**Eugene School District 4J
ROOSEVELT MIDDLE SCHOOL**
680 East 24th Avenue
Eugene, OR 97405
CIP No. 410.566.001

ADDENDUM NO. 6

This Addendum forms a part of the Contract Documents and modifies the original Bidding Documents dated February 18, 2015 and subsequent addenda as noted below. Acknowledge receipt of this Addendum in the space provided on the Bid Form. Failure to do so may subject the Bidder to disqualification.

M-121A

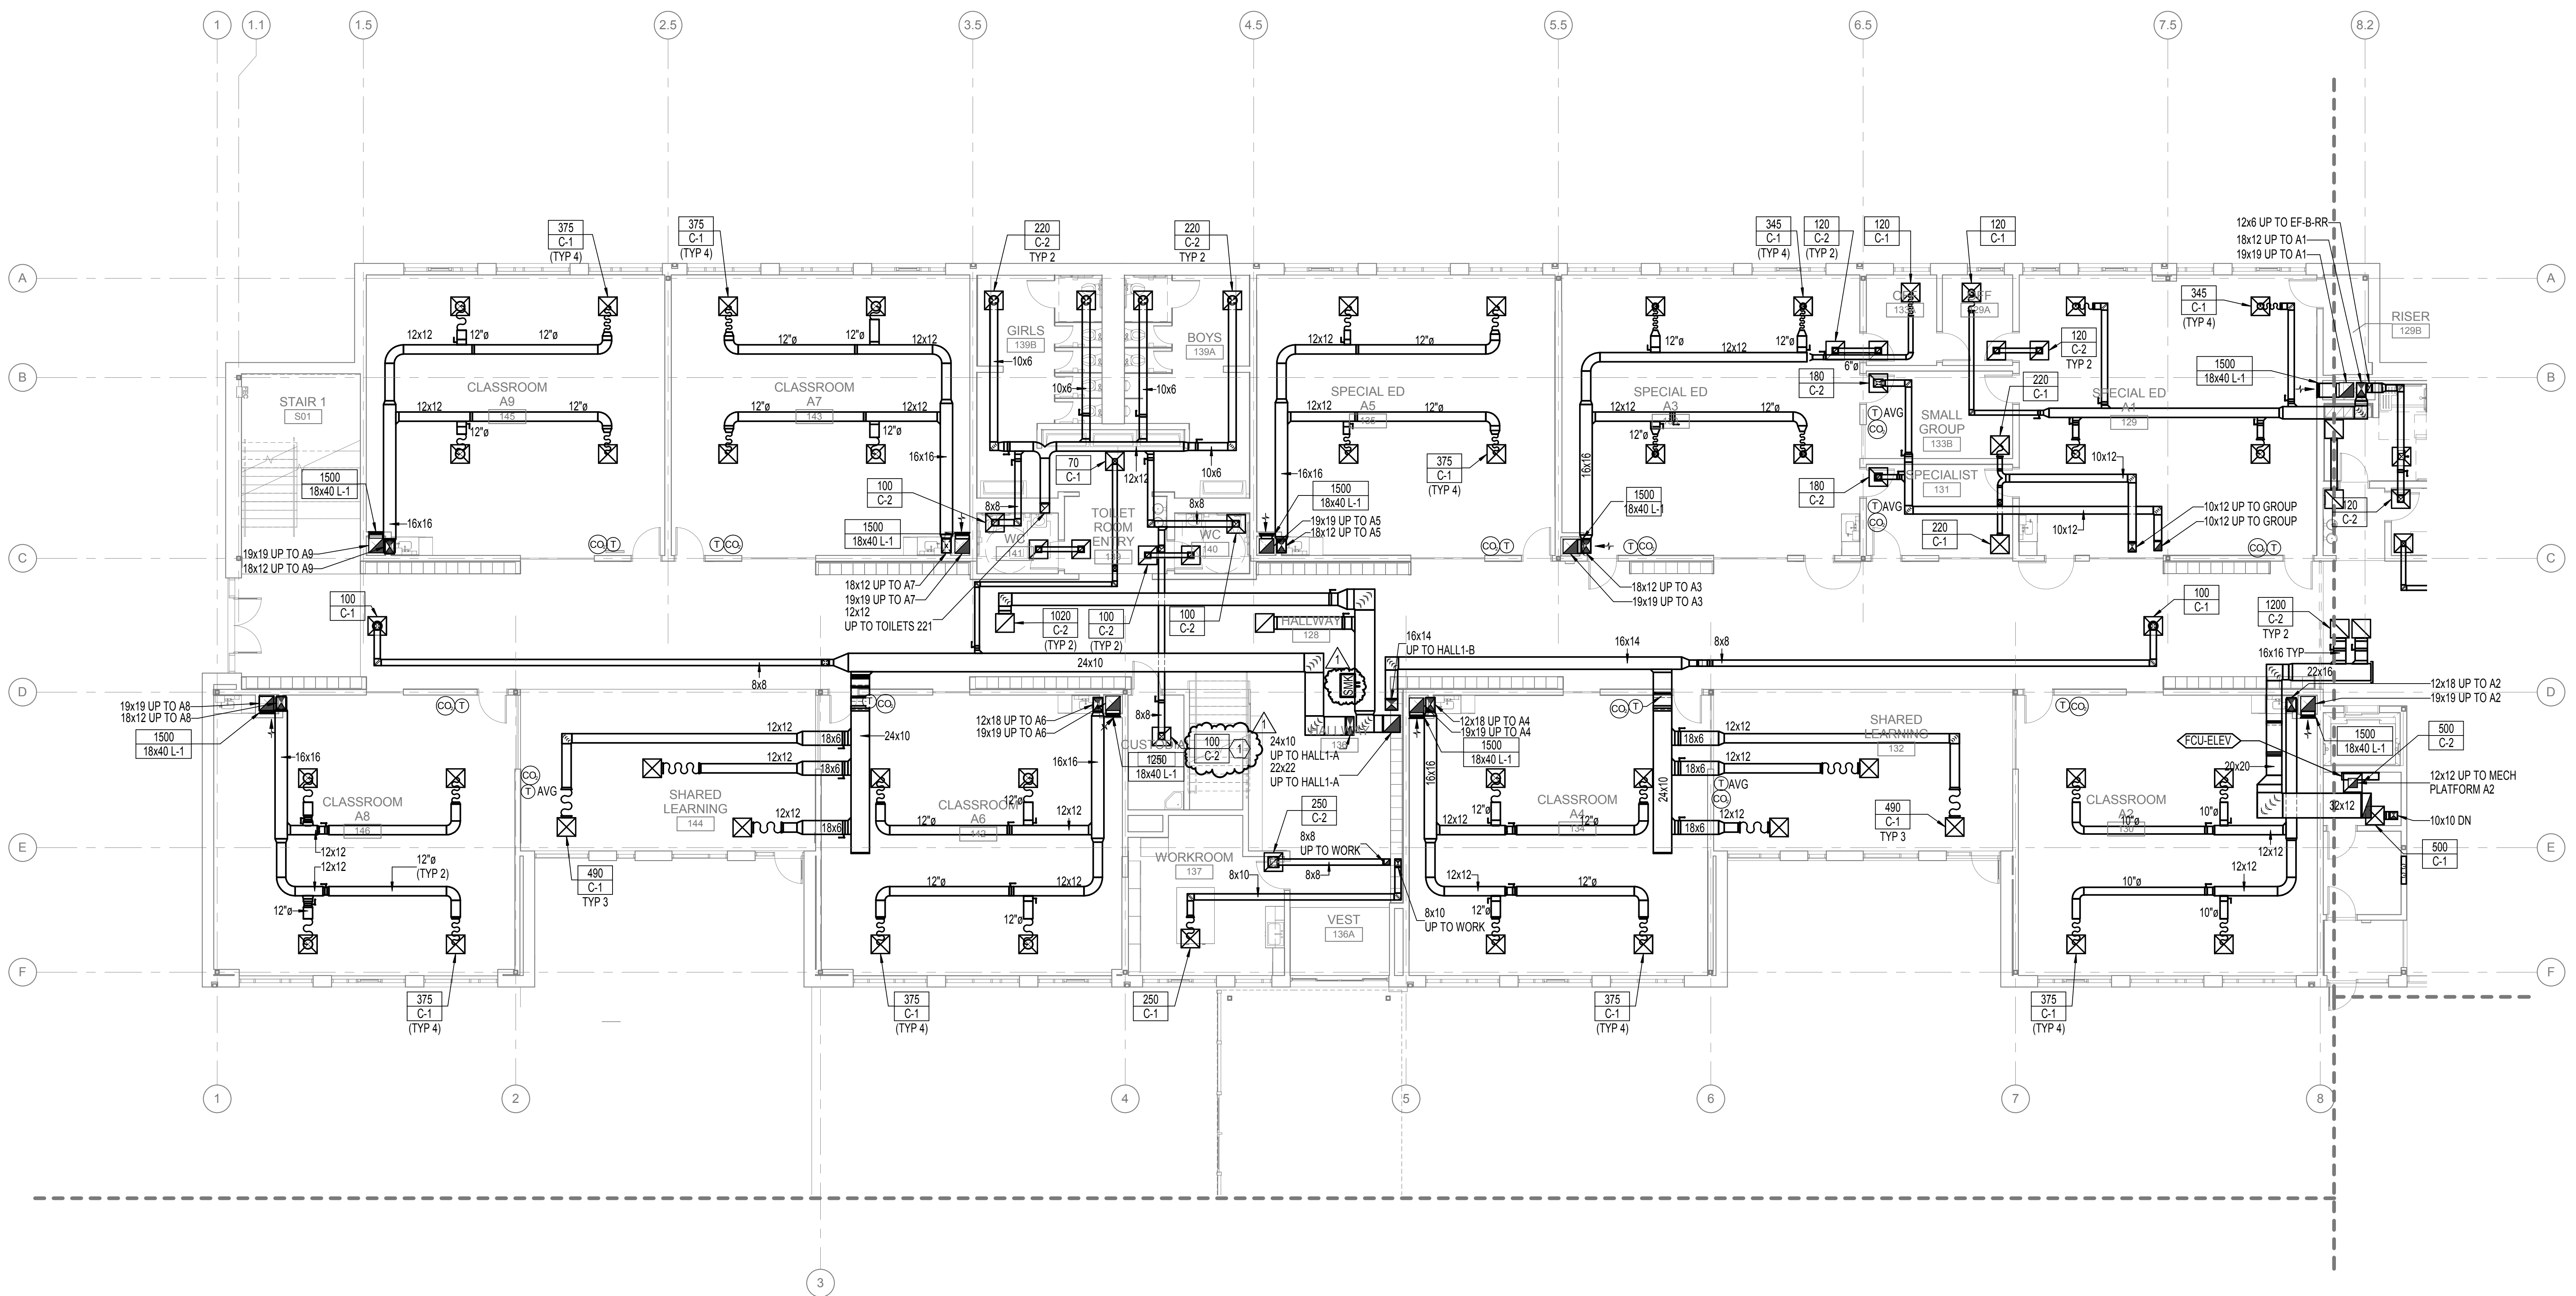
- A. Replace Sheet with revised Sheet M-121A: Add radiation damper to exhaust grille serving janitor's room. Add smoke detector to AH-HALL1-A return duct.

M-121D

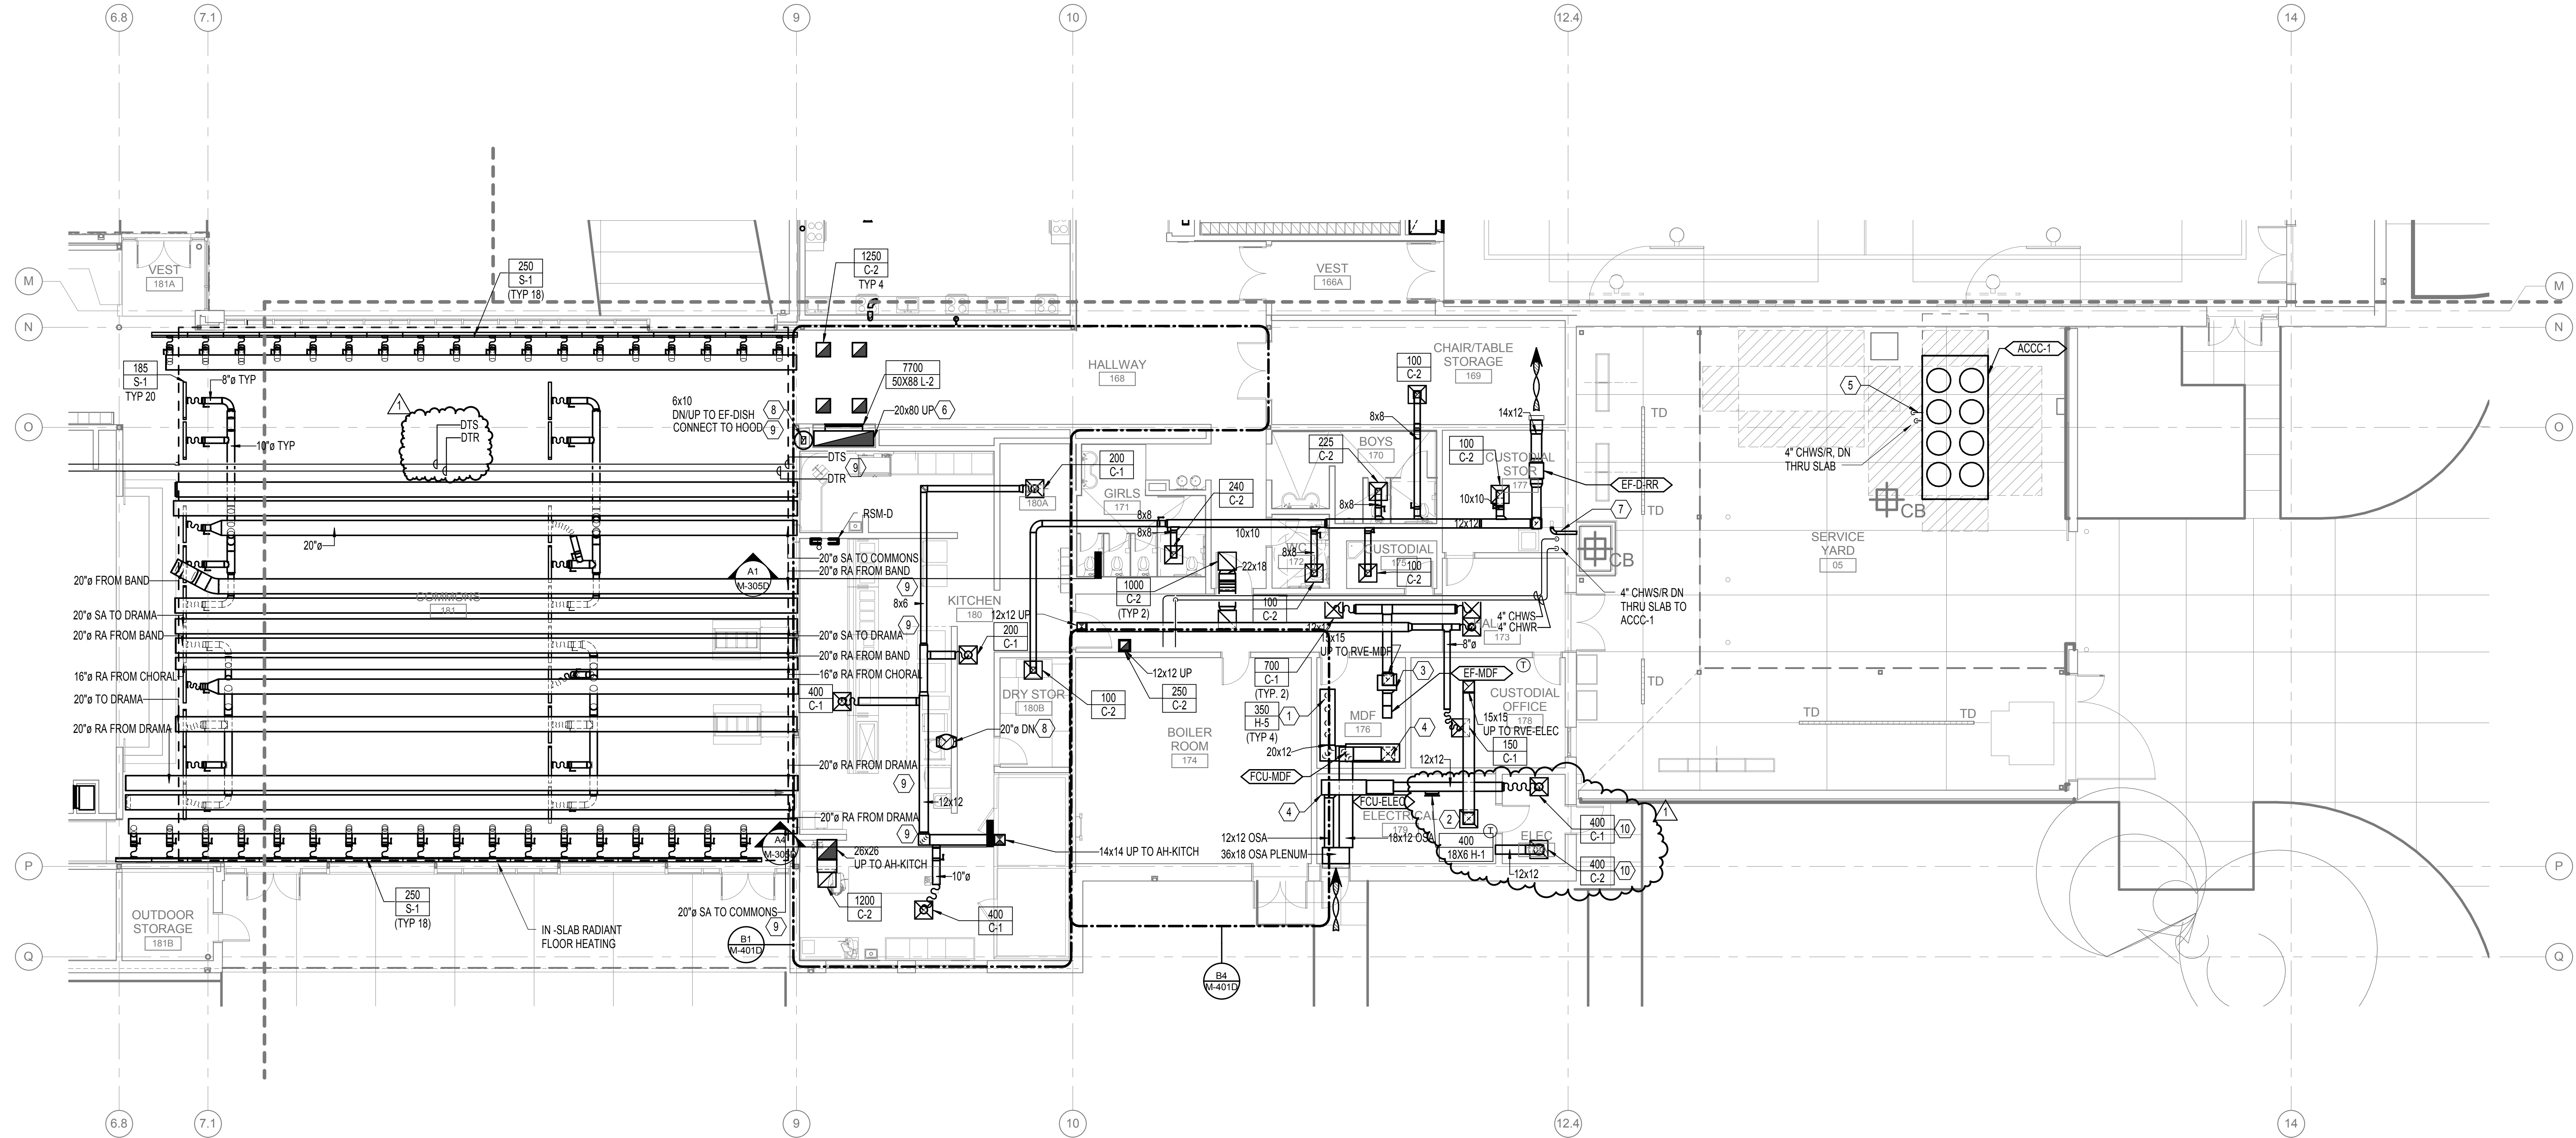
- A. Replace Sheet with revised Sheet M-121D: Delete sizes shown on DTS and DTR (see hydronic diagram for sizes). Revise supply and return at Electrical Room 179A to include ceiling mount grilles with radiation dampers.
